**Permission sought for a mixed use & residential development on a site area of 6.3Ha, within the Clonburris Strategic Development Zone (SDZ) and in the townland of Cappagh, Dublin 22.**

**ADDITIONAL INFORMATION**

**REG. REF. SDZ22A/0010**

**Fig. 6 – Indicative feasibility for entire CUC-S4 & CSE lands**

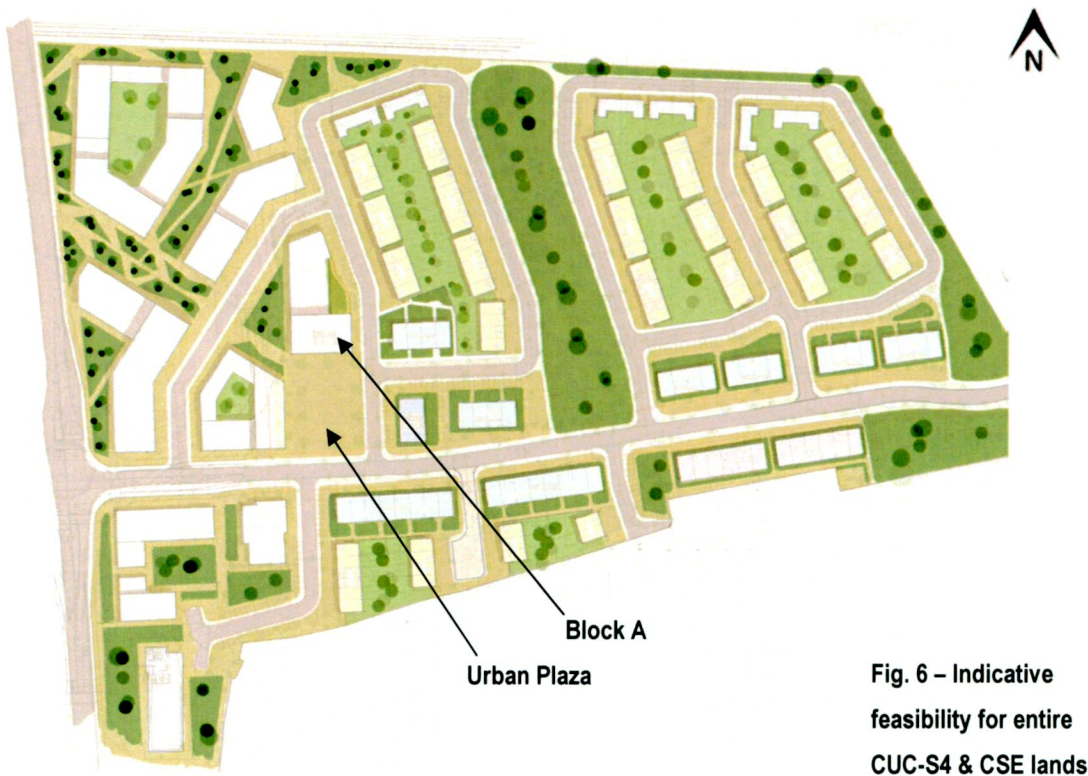
(b) The proposed plaza and surrounding block form should be significantly redesigned in line with the Design Criteria in Table 2.10.3 of the Planning Scheme. A detailed design of the plaza should be submitted, including how it would connect with the remainder of the Clonburris Urban Centre and wider area as indicated in the Planning Scheme. The plaza should be enclosed on more than one side.

It can be seen from the submitted feasibility that a proposed street connection from the plaza / subject application site to the western side of CUC-S4 can be created via a looped link street that would pass the proposed creche and retail/commercial unit in Block A. Development on the western part of the CUC-S4 lands could be configured with enclosed private courtyard parks over basement parking. A diagonal street leading from the plaza toward the train station can be accommodated, catering for pedestrian and cyclist accessibility, in the manner as suggested within the masterplan layout contained in the SDZ Planning Scheme.

Please refer to both the submitted site layout plan (Davey-Smith drawing no. 2004-PL-002) and landscape masterplan (RMDA Landscape Plan, drawing no. 01LP), as well as RMDA Landscape Detail Plans (drawing no.s 04(i) & (ii)) which illustrate that the proposed urban plaza in the south-west part of the site has been increased. The proposed plaza occupies an area of c.1,884m<sup>2</sup>, which is an increase of 768m<sup>2</sup> from the initial proposal of c.1,116m<sup>2</sup>.

Fig. 7 – Model of indicative feasibility for CUC-S4 & CSE lands

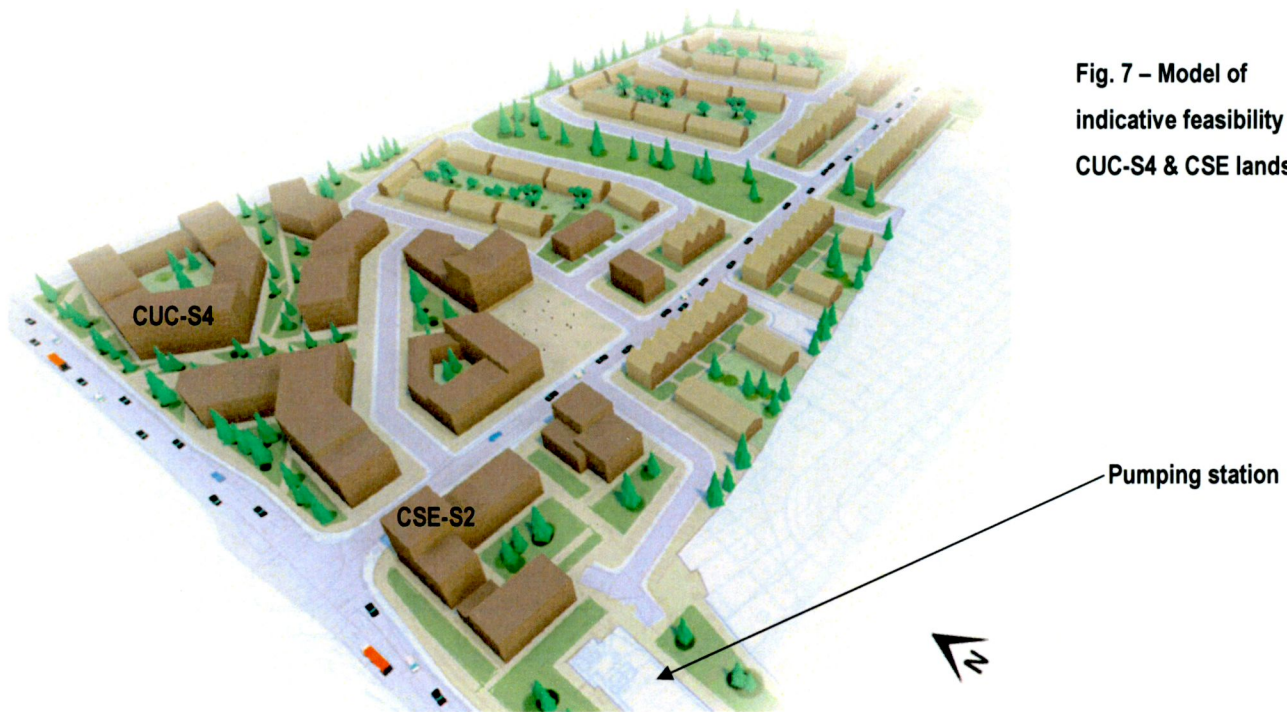
*(d) Master planning of how the proposal would integrate with the Planning Scheme and help deliver the rest of the Clonburris Urban Centre is required. The potential future development of the remainder of the CUC-S4 and CSE-S2 subsectors should be indicated. This indicative masterplan should indicate potential future:*

Davey-Smith Architects have prepared an indicative masterplan of how the proposed development can integrate with the adjoining third party lands within the SDZ, including setting out how the proposed development can be combined with future possible development on the adjoining lands within the CUC-S4 and CSE subsectors, as illustrated in Figs 3, 6 & 7. Fig. 6 incorporates the remaining CUC-S4 lands to the immediate west/north-west of the subject site and the remaining CSE lands to the west/south-west of the application site, while Fig. 7 illustrates a model of what the remainder of the CUC-S4 and CSE-S2 lands could be developed in terms of volume and building height. Please note that these areas are outside of the ownership/control of the applicant and are indicative only, but represent what could be delivered on these land parcels having regard to the requirements/standards of the SDZ Planning Scheme. It should also be noted that the feasibility in Fig. 6 has taken into consideration how the proposal integrates with the existing lands to the west, including the park and ride facility, and the pumping station, as also illustrated in Fig. 7 below.

For the remainder of the CUC-S4 lands, the masterplan takes into consideration a block form and layout that will knit together with the proposed application to provide a coherent urban form that directly reflects the design intent as set out in the Planning Scheme for this area. The submitted feasibility sets out that the remaining CUC-S4 lands can accommodate c.235 no. units in a series of buildings that would range in height from 3-4-5-6 storeys. This, combined with the current proposal of 95 no. units on CUC-S4 lands provides for a density range of 67-150 units per hectare, which accords with required density range of 67-150 units per hectare, as set out in the SDZ Planning Scheme.

Fig. 11 – Sample of proposed Communal Open Space Railing

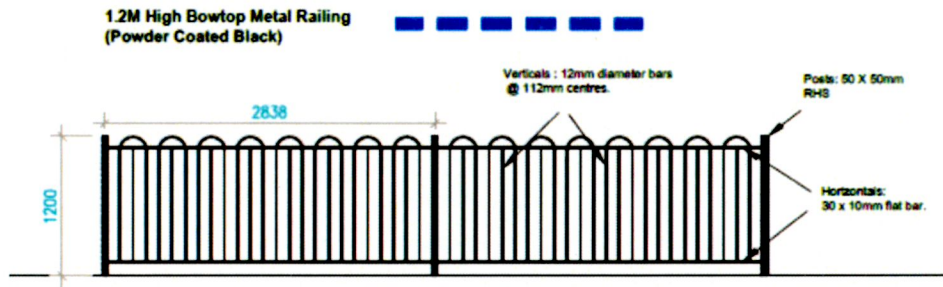
*(c) Further detail and a revised design for communal open space should be submitted. This include revised boundary treatment, consideration of sunlight access and how it will tie in with potential development to the west.*

A 1.2m railing will be implemented along the boundary of the communal open space, with details of same illustrated on page 3 of the submitted RMDA Additional Information Response document, and the submitted Boundary Plan (drawing no. 02BP) – please refer to same.

The communal open spaces are designed to act as a shared amenity space for the residents of Blocks A and B only, with a specific space designated to each building/block. This space will be for the sole use of the residents of these blocks and to that end a 1.2m railing will be implemented along the boundary of the communal open space to define this space as being associated with the adjoining apartment building but being of a size and type that allows a visual connection both into and out of these communal spaces.

Fig. 15 – Indicative feasibility for entire CUC-S4 & CSE lands demonstrating compliance to the street hierarchy & urban grain of the SDZ Planning Scheme

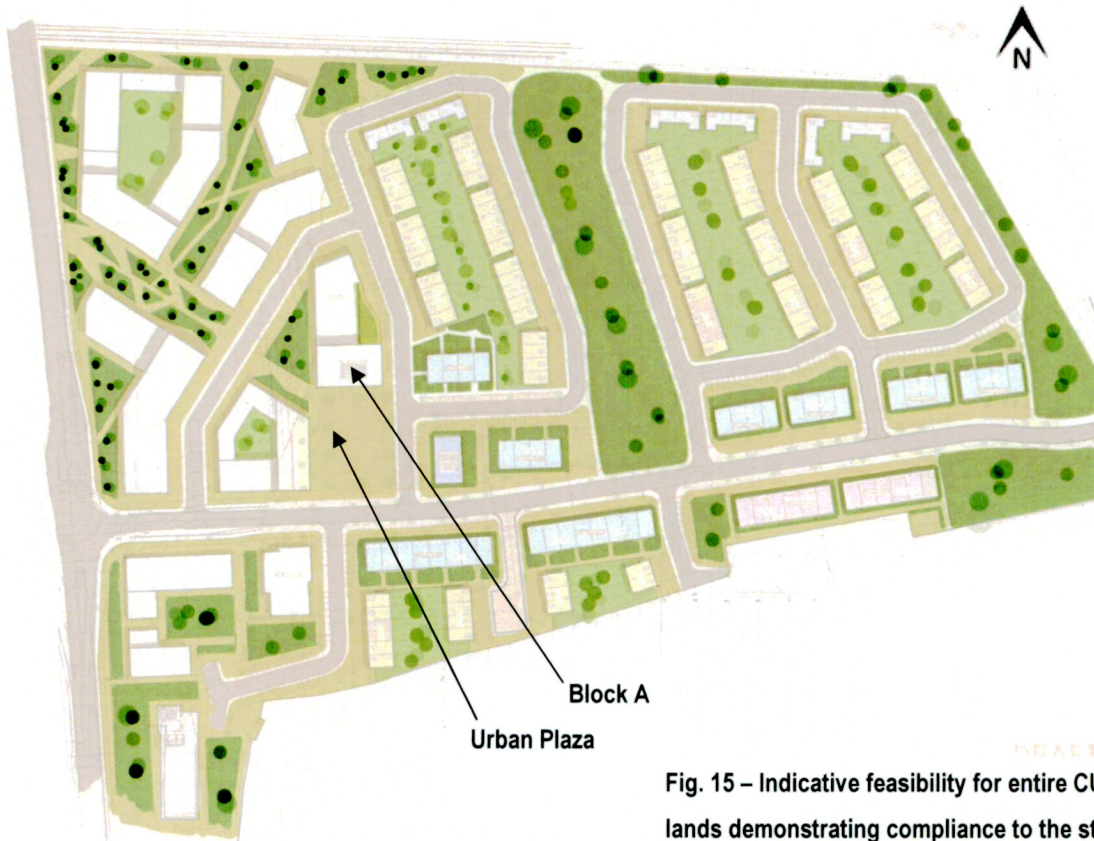
*Section 2.2.4 of the Planning Scheme outlines that the centre line and alignment of the Local Streets and Home zones are flexible with the exception of streets with frontages prescribed under Section 3 (Development Areas). In this instance, the application site contains prescribed frontages in the form of Avenue, Park and Railway Frontages (Figure 3.1 refers). The Local Street alignment in the north western part of the site, in CUC-S4, is amended and Local Streets/frontages are not provided around the urban plaza as indicated in the Planning Scheme. This would have Avenue Frontages onto it. This should be provided. The Planning Scheme does not provide for the easternmost cul-de-sac to the south of the Link Road. This should be considered for omission and/ or a detailed rationale provided.*

The enclosed revised site layout plan has enlarged the proposed urban plaza and provided building frontage onto it. The lands to the immediate west are in third party ownership, however, as outlined in detail above, the project architects Davey+Smith have prepared the submitted indicative feasibility layout for the remainder of the CUC-S4 lands which demonstrates that future, further enclosure of the plaza can be facilitated. Cognizance has also been paid to section 2.2.4 of the SDZ Planning Scheme, as well as Figures 2.2.1 and 2.4.2 of the Planning Scheme.

Figure 2.4.2 of the Planning Scheme identifies 'Fine Urban Grain' locations in the Planning Scheme. This diagram also identifies fixed building lines, which largely front to main streets with flexible inner lines between blocks, to which the proposed development in CUC-S4 complies. Blocks F and K directly address the main east-west link street to the immediate south. Block A has been amended to provide a more defined and stronger frontage onto the plaza, while the feasibility layout for the remainder of the CUC-S4 lands demonstrate that proposed urban blocks can further enclose the plaza and that proposed local streets can be facilitated and tie into the current proposed site layout plan.

The principle of main link route through the lands is already permitted via the east-west main link street traversing the application site. The proposed site layout plan provides for a strong urban street frontage along this route thus creating a defined sense of enclosure that has an active frontage and is passively supervised. The remainder of the proposed internal road network on the application site is comprised of local streets and homezones, which given the need to retain hedgerows and accommodate permitted infrastructure, is considered to follow the principles of the street hierarchy and urban grain as set out in the SDZ Planning Scheme. The principle of all designated streets within the Planning Scheme is fixed and the alignment of each street including its centre line (i.e. refer to Figure 2.8.5 in Section 2.8 of the Planning Scheme – "Building Centre Line & Urban Grain") are either fixed or flexible depending on typology. The planned street hierarchy for the SDZ lands is illustrated in Figure 2.2.1. The Arterial Streets and Link Streets are fixed whereas the local streets are flexible. It is clear from the submitted site layout plan that the proposed development accords with these parameters.
